**ECN/PCN No.: M1104**

<b>Product Description:</b> Molding Type Power Inductor		<b>Abracon Part Number / Part Series:</b> ASPI-1040HI	<input checked="" type="checkbox"/> Series
			<input type="checkbox"/> Part Number
<b>Affected Revision:</b> A	<b>New Revision:</b> B	<b>Application</b>	<input type="checkbox"/> Safety
			<input checked="" type="checkbox"/> Non-Safety

2. Production Dimensions

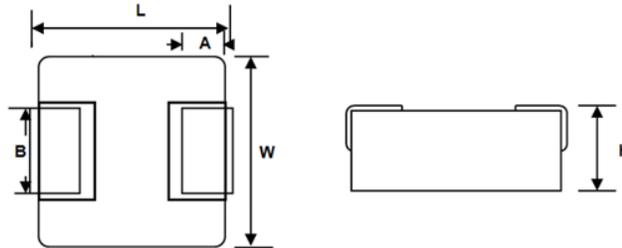
A	A'	B	L	W	H
2.0 ±0.5	2.5 ±0.1	3.0 ±0.5	11.15 ±0.35	10 ±0.3	4 max (4.0 ±0.25 for R16)

A	B	L	W	H
2.0 ±0.5	3.0 ±0.5	11.5 max	10 ±0.3	4 max

3. Reflow profile

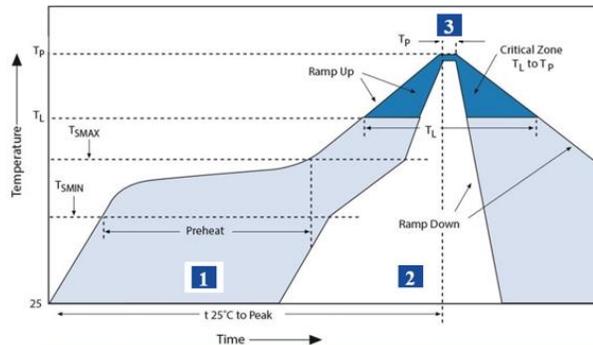
Zone	Description	Temperature	Times
1	Preheat	$T_{SMIN} \sim T_{SMAX}$ 150°C ~ 180°C	60 ~ 120 sec.
2	Reflow	$T_L$ 230°C	40 sec.
3	Peak heat	$T_p$ 250°C ± 5°C	10 sec. MAX
